Access Compliance Report

Public Rights-of-Way

(Curb Ramps)

Intersection ID: 47575	Main Street: GLENBURN_LN	Cross Street: GAILES_DR	Location: NW
ADA ID: 2F089BA149DD	Ramp Type: PerpDiag	Initial Pass/Fail: Fail	Overall Compliance: No
Severity Score: 25			
Codes/Mitigation Info/Possible Solution		Field Measurements/Component Compliance

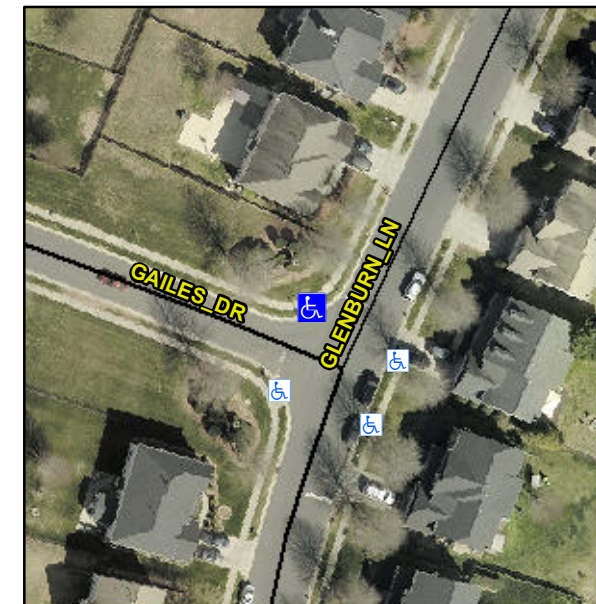
R304.5.3

Compliance	Description	Data	Compliance	Description	Data
N/A	Ramp Length (in)	49.0	Yes	Ramp Slope (%)	6.3
Yes	Ramp Width (in)	48.0	No	Ramp XSlope (%)	9.1
N/A	Flare Type LT	N/A	N/A	Flare Type RT	N/A
N/A	Flare Slope LT (%)	N/A	N/A	Flare Slope RT (%)	N/A
N/A	Flare Traversable LT?	N/A	N/A	Flare Traversable RT?	N/A
N/A	Landing Length (in)	N/A	N/A	DWS Provided?	N/A
N/A	Landing Width (in)	N/A	N/A	DWS Contrast?	N/A
N/A	Landing Slope (%)	N/A	N/A	DWS Length (in)	N/A
N/A	Landing X Slope (%)	N/A	N/A	DWS Full Width?	N/A
N/A	Landing Curb? (Y/N)	N/A	N/A	DWS Offset (in)	N/A
N/A	Shared Landing?	N/A			
N/A	Gutter Ponding?	N/A	N/A	Gutter Slope (%)	N/A
N/A	Gutter Lip Ht (in)	N/A	N/A	Gutter X Slope (%)	N/A
N/A	Painted X Walk1?	No	N/A	Painted X Walk2?	No
	X Walk 1 Direction	To SW		X Walk 2 Direction	To SE
N/A	X Walk 1 Width (in)	N/A	N/A	X Walk 2 Width (in)	N/A
	X Walk 1 Slope (%)	6.5		X Walk 2 Slope (%)	3.5
	X Walk 1 X Slope (%)	3.7		X Walk 2 X Slope (%)	6.2

N/A	Ramp inside XWalk1?	N/A	N/A	Ramp inside XWalk2?	N/A
	Road Slope (%)	9.1	N/A	Clear Space?	N/A
	Road X Slope (%)	1.5	N/A	Clear Space to XWalk (in)	N/A
N/A	Any Obstructions?	N/A	N/A	Storm Grate/Utility Hazard?	N/A
	Obstruction Type			Storm Grate/Utility Type	
		N/A			N/A
		Yes		Surface Condition? (G/P)	Good

Remove & Replace Curb Ramp With Two New Directional Ramps or Equivalent.
